Project:	<b>Hanging Heaton, Batley</b>	Doc No:	<b>24004-LE-ZZ-05-RP-D-0001</b>
Subject:	<b>Drainage Strategy</b>	Rev:	<b>P01-S2</b>
Prepared by:	<b>M Fenton</b>	Date:	<b>26/06/2024</b>
Approved by:	<b>W Farrell</b>	Date:	<b>26/06/2024</b>

Lynas Engineers have been appointed by Mandale Homes to undertake a drainage design to support a planning application (ref 2023/93597) for the 'Hanging Heaton' residential development in Batley.

**Consultation Response from KC,  
Lead Local Flood Authority**

**2023/93597 east of, Mill Lane, and Heaton Grange, Hanging Heaton, Batley, WF17 6EN**

**HYDROBRAKE TECHNICAL SPECIFICATION**

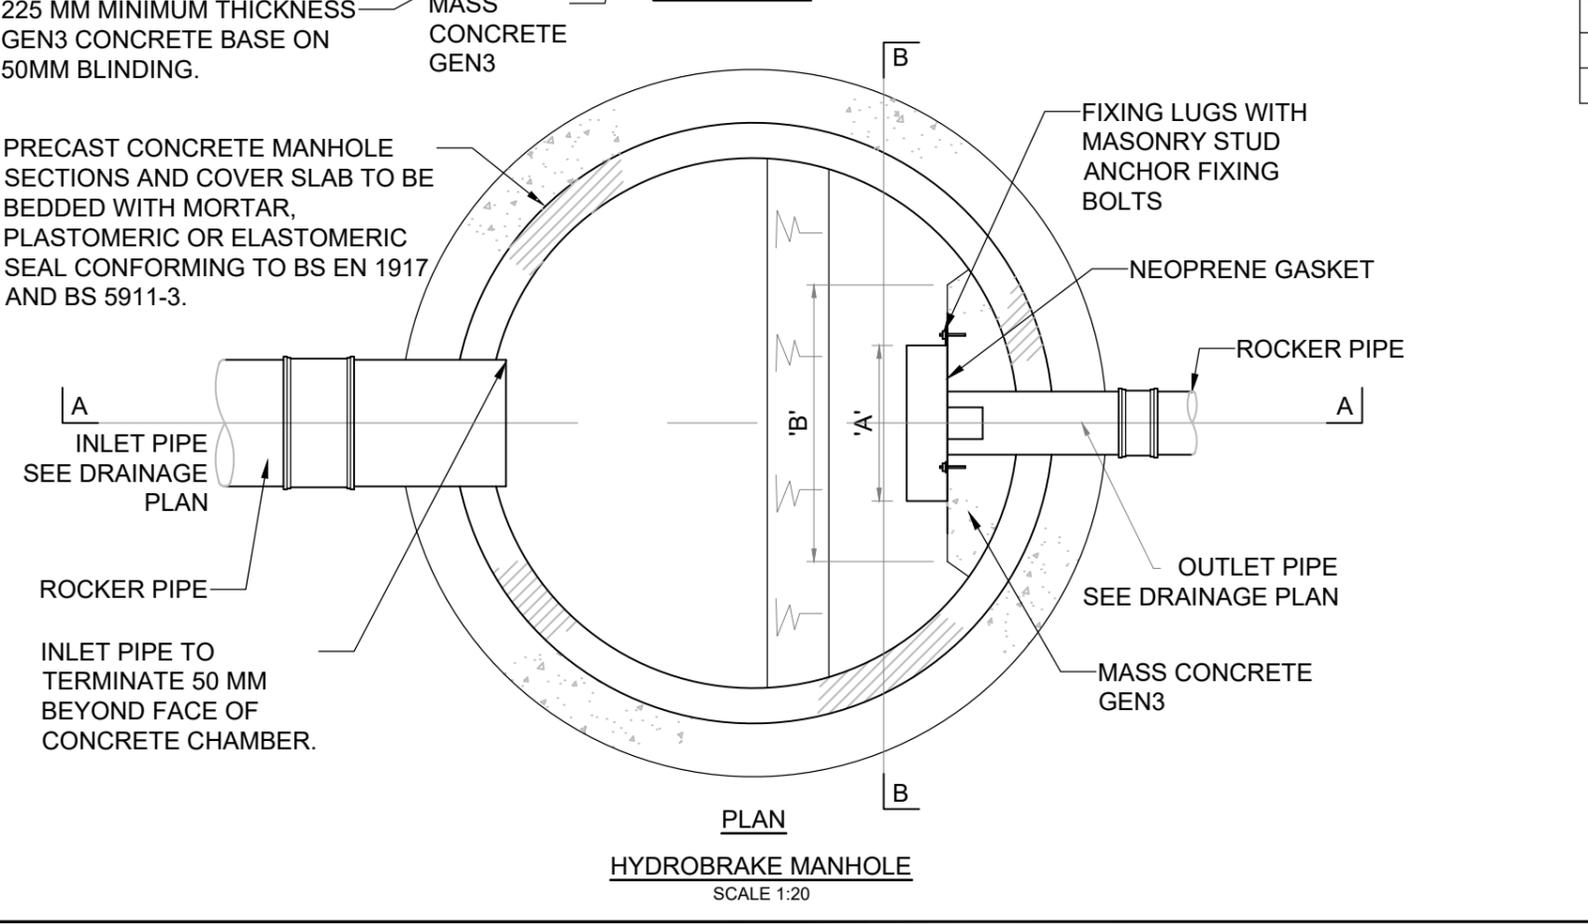
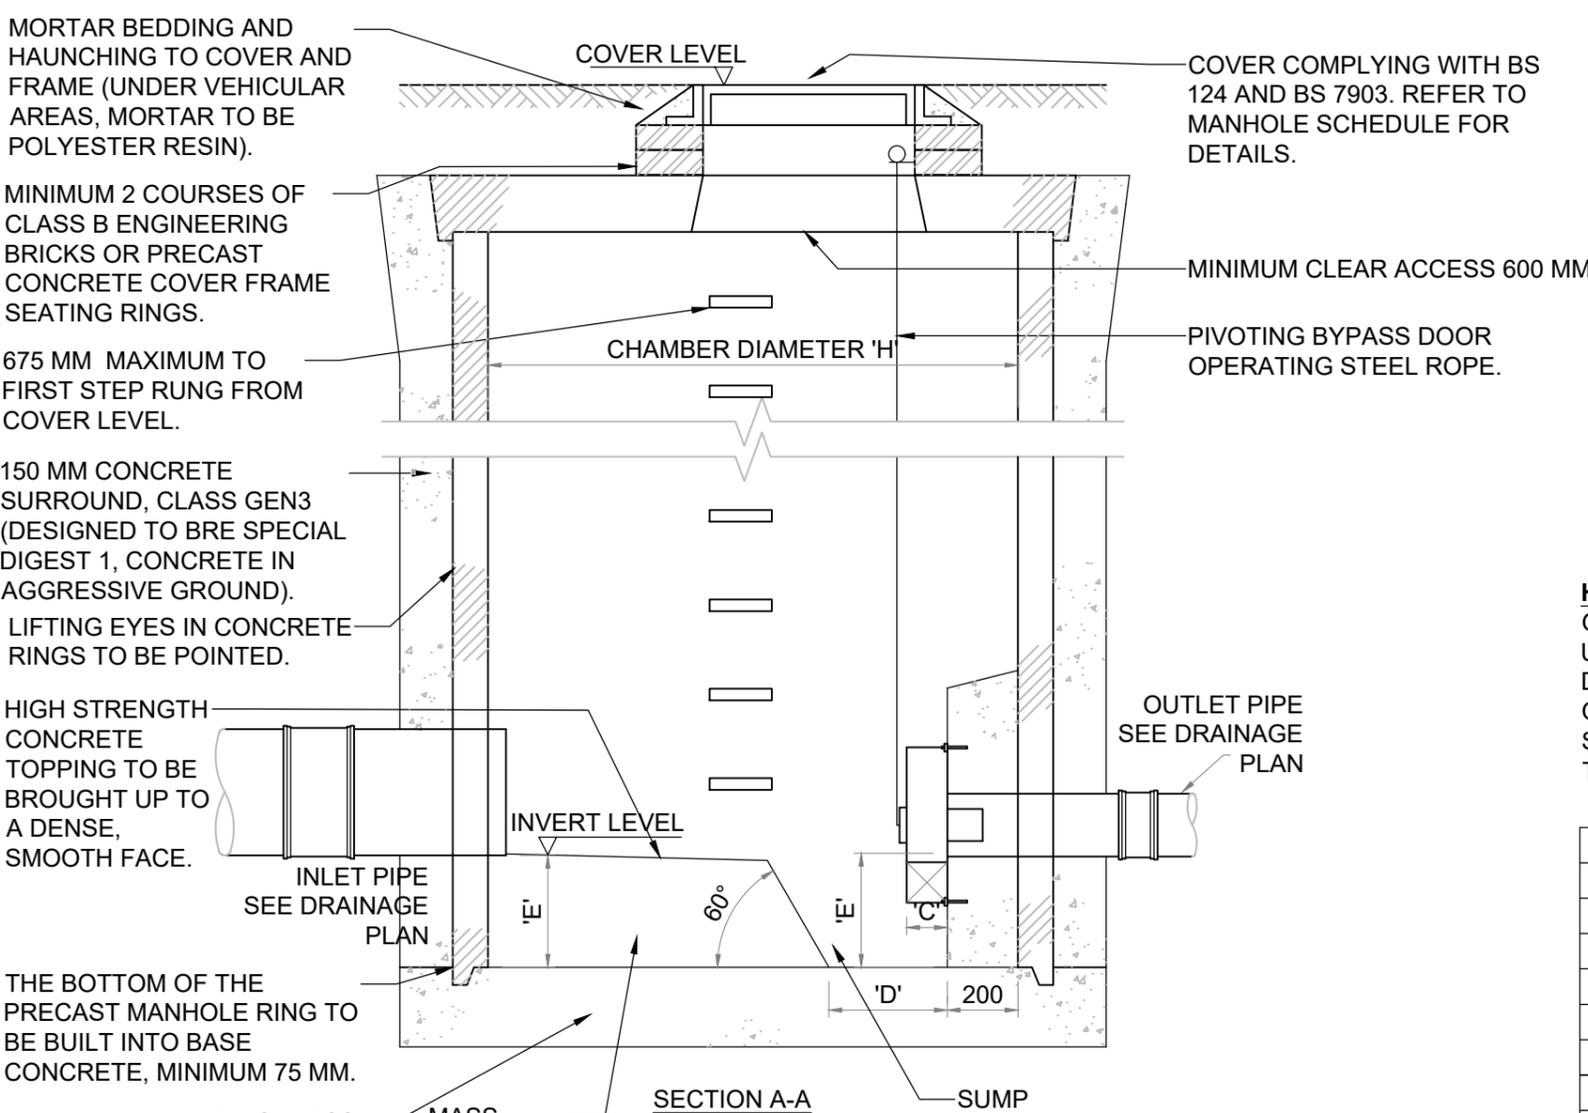
- The off-site surface water discharge should be subject to a minimum flow control device outlet diameter of 75mm. **Hydrobrake Ref SHE-0075-2500-1000-2500.**

The off-site surface water discharge should be attenuated to the equivalent Greenfield Run-off Rate (5.0 l/s per ha) but subject to a minimum flow control device outlet diameter of 75mm.

Manhole Reference:	S15	
Cover Level (m):	63.670	Invert Level (m): 62.208
Hydrobrake Reference:	SHE-0075-2500-1000-2500	
Design Head (m):	1.0m	
Design Flow (l/s):	2.5	
Inlet Pipe diameter (mm):	300	
Outlet Pipe diameter (mm):	150	
Dimension 'A' (mm):	440	Dimension 'E' (mm): 320
Dimension 'B' (mm):	645	Dimension 'F' (mm): 785
Dimension 'C' (mm):	85	Dimension 'G' (mm): N/A
Dimension 'D' (mm):	170	Dimension 'H' (mm): 1800

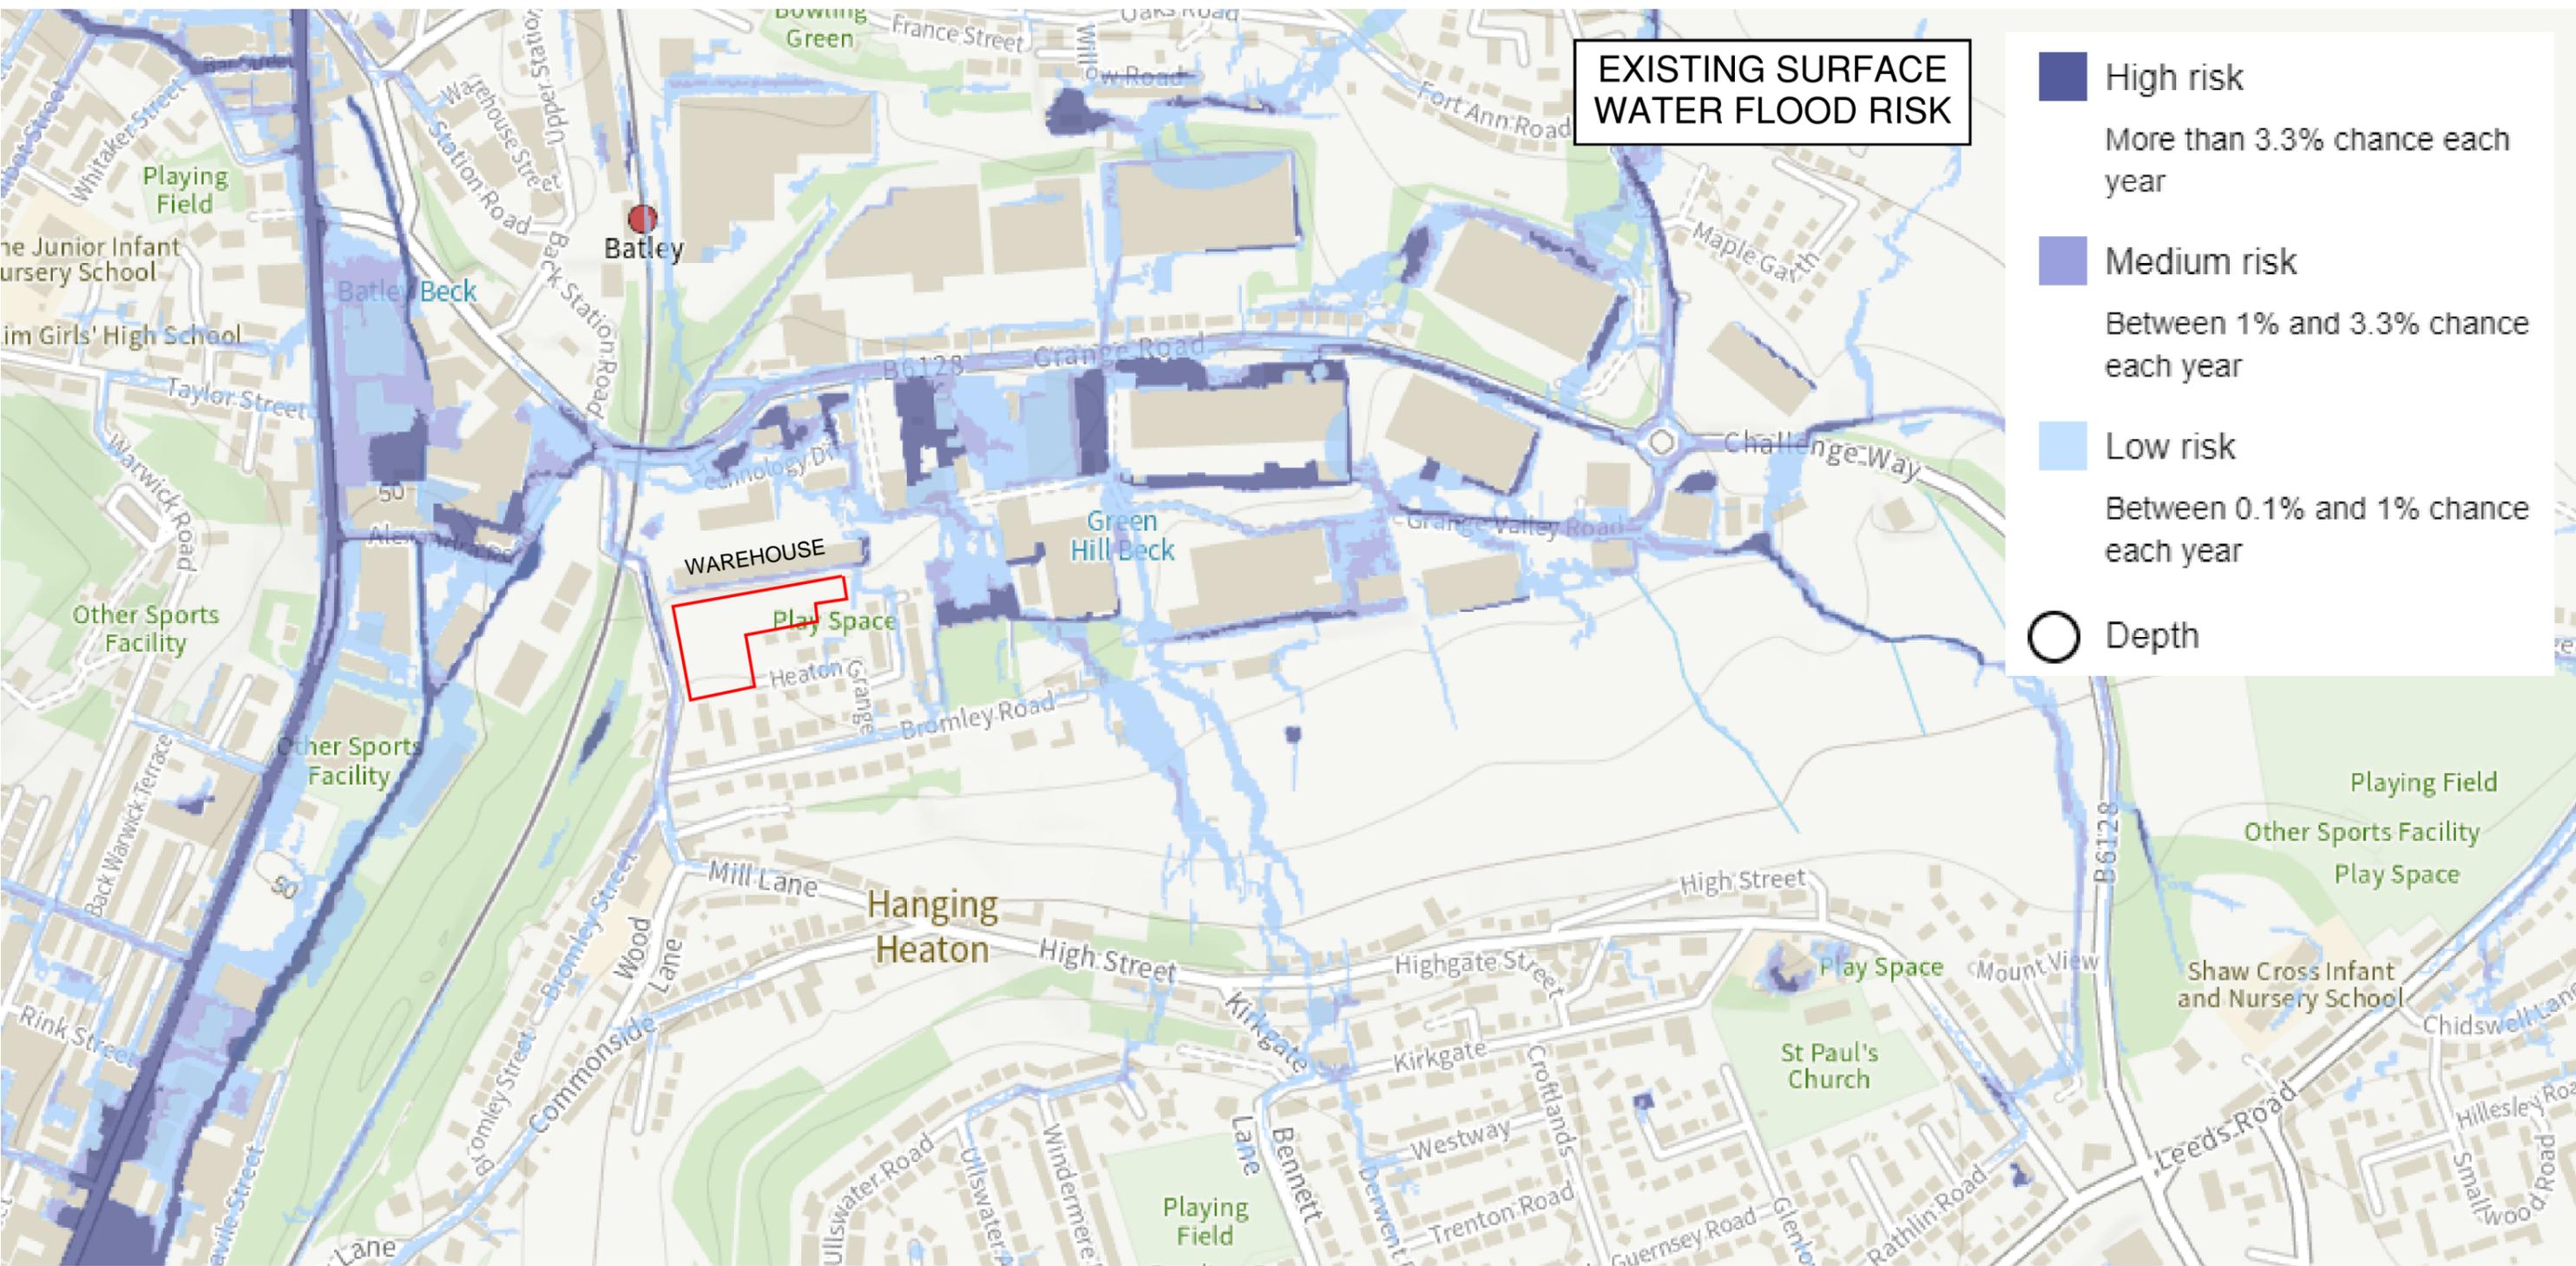
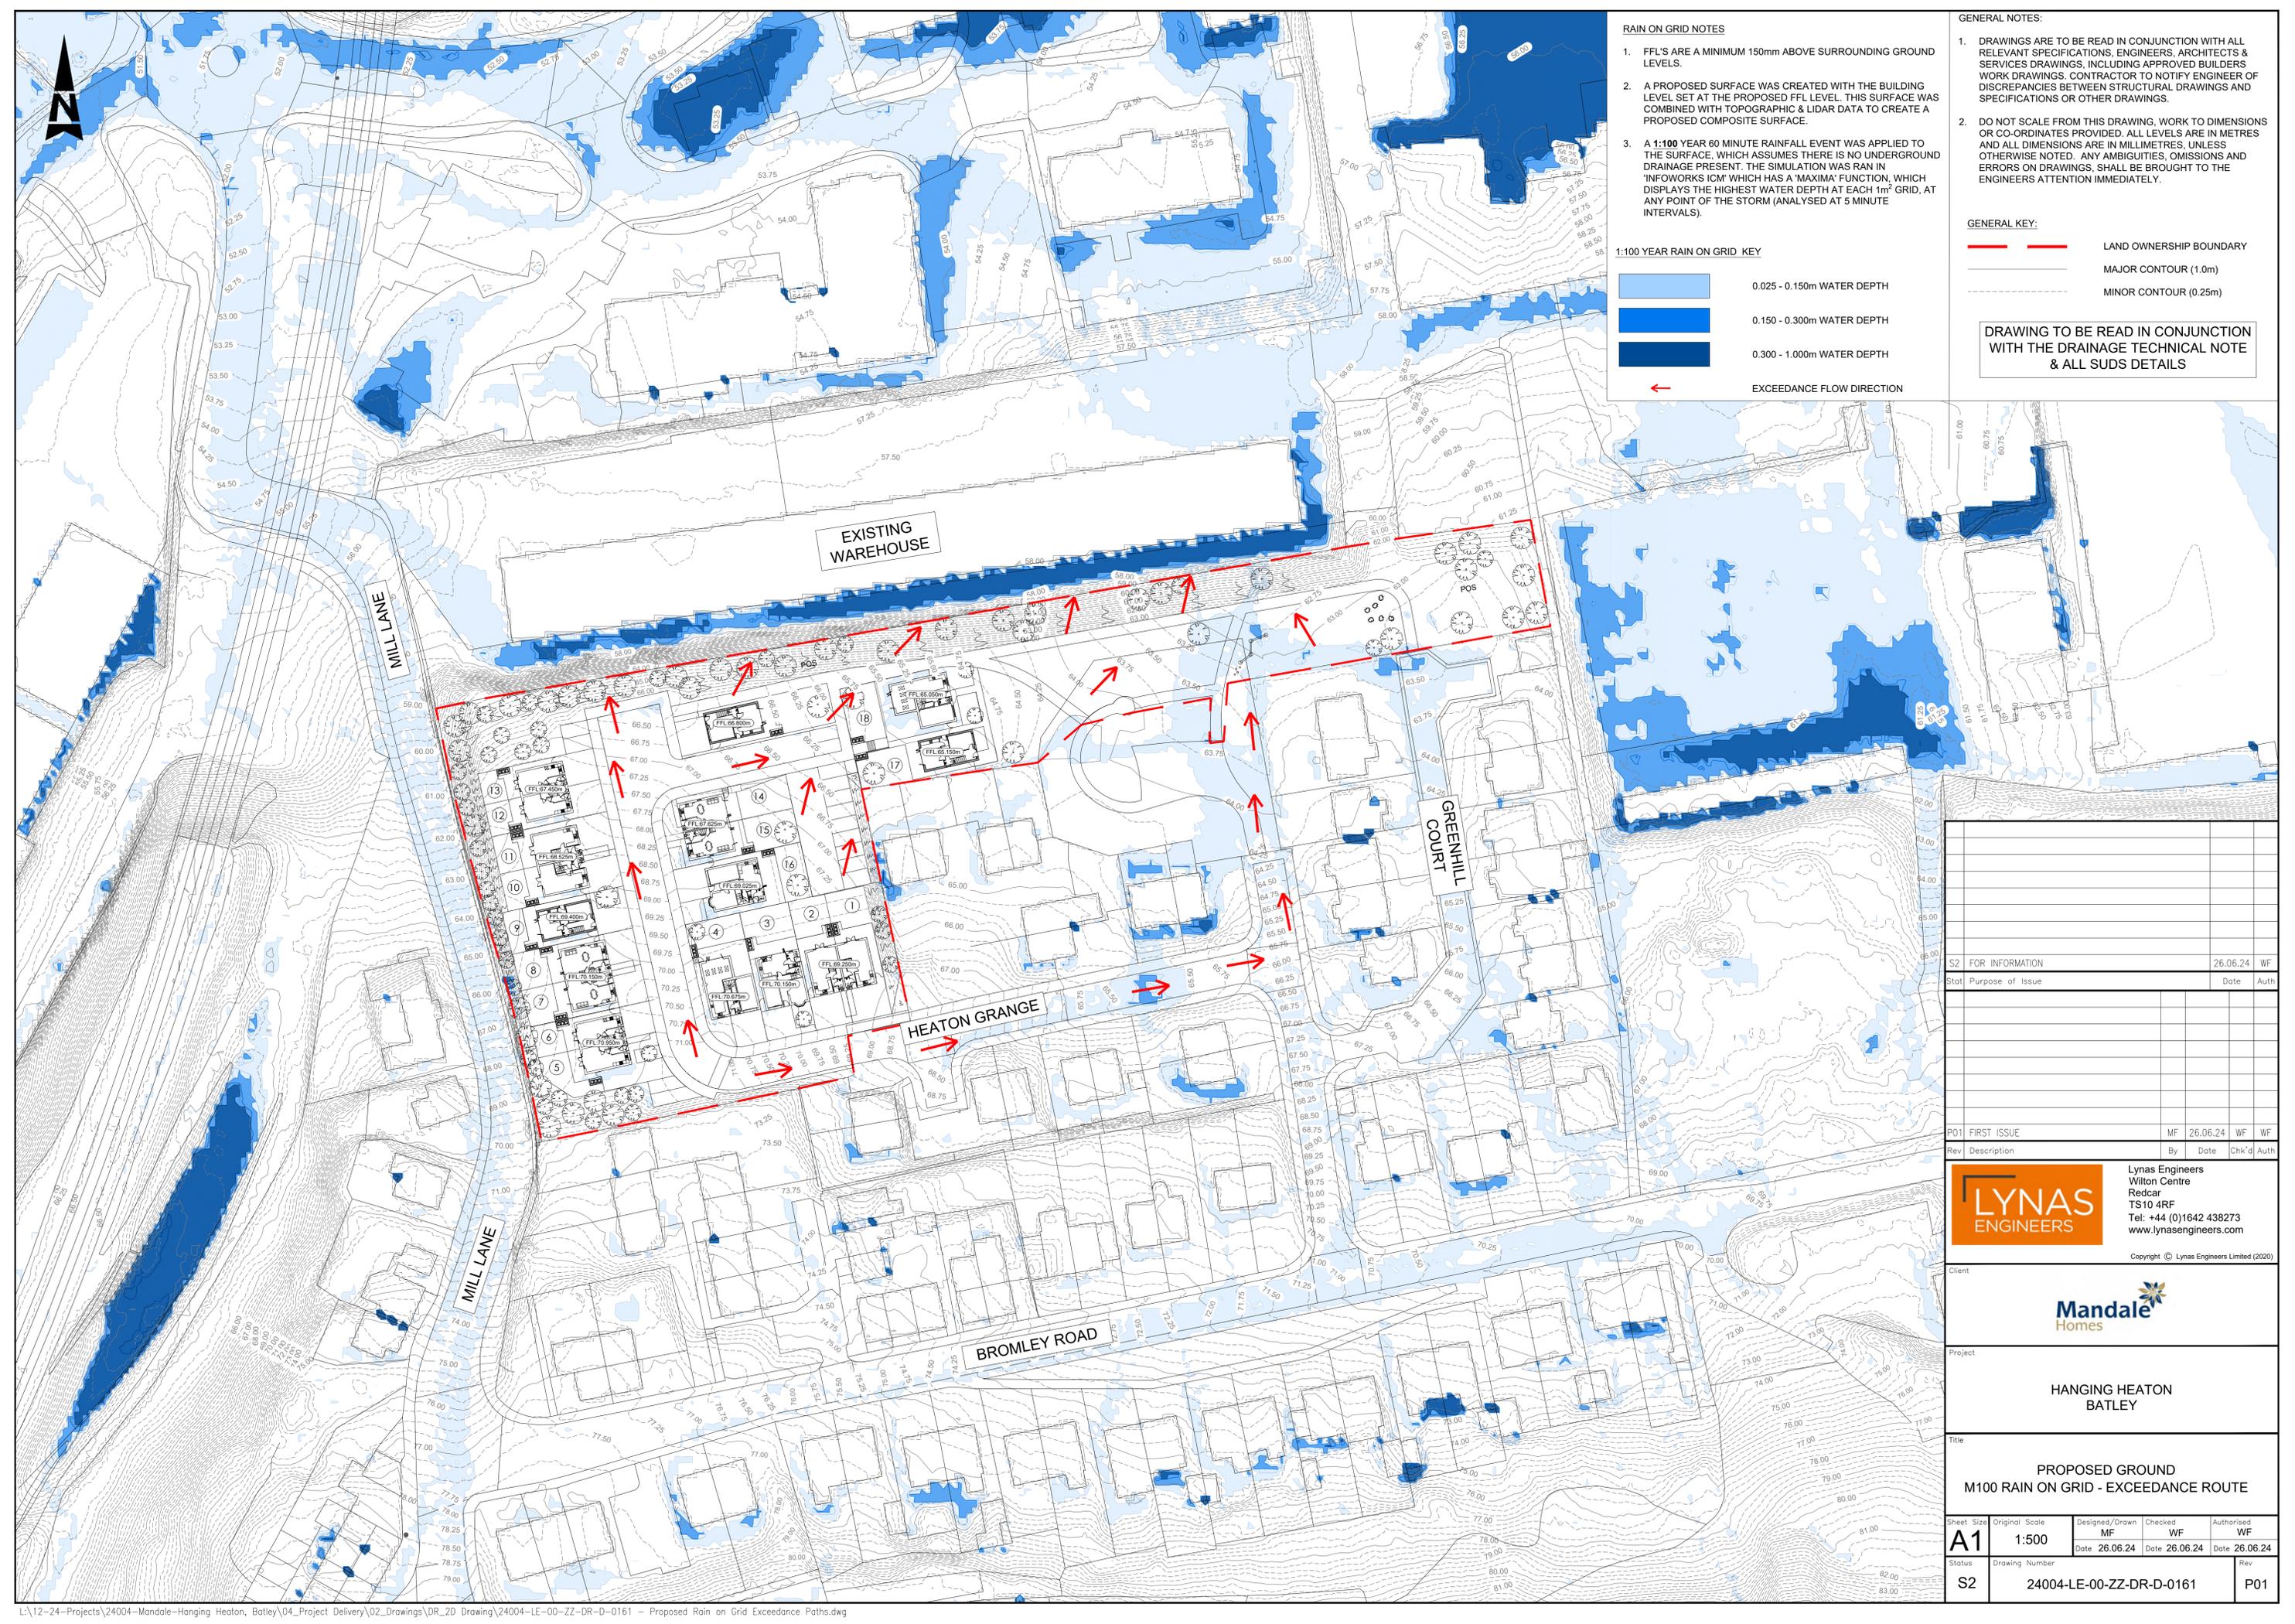
- Temporary surface water drainage for the construction phase required, including attenuation arrangements. **Refer to Appendix E for CSWMP. Attenuation tank to be constructed as part of the first phase of development.**

**DR10 Construction Phase Surface Water Flood Risk and Pollution prevention plan.**
